Attention Director Infrastructure Projects, Planning Services, Department of Planning and Environment GPO Box 39, Sydney, NSW, 2001	Name: <u>Sabina Chater</u>
	Address: <u>48 Poinciana blvd</u>
Application Number: SSI 7485	Suburb: <u>Broadbeach waters</u> Postcode <u>4218</u>
Application Name: WestConnex M4-M5 Link	Signature: <u>[Signature]</u>
Please include / delete (cross out or circle) my personal information when publishing this submission to your website Declaration : I HAVE NOT made any reportable political donations in the last 2 years.

Submission in relation to: Application Number - SSI 7485
Application name - WestConnex M4-M5 Link

The EIS states in 6.5.8 Darley Road civil and tunnel site (C4) that:

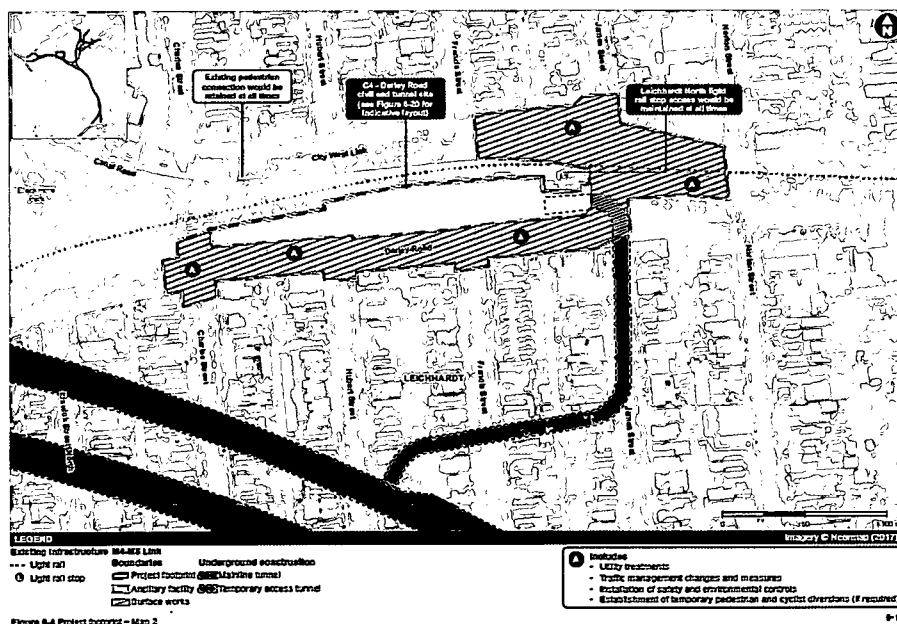
1. I object to the EIS because it fails to describe the temporary changes to Darley Road, Leichhardt to enable access to and from the ancillary facility that would likely be required in relation to the Darley Rd site and instead allows for the final plan to be decided by the contractor.

It is not clear how continued access, pedestrian and cyclist movement will be preserved and I am concerned that the impacts have not been correctly identified and assessed by the proponent.
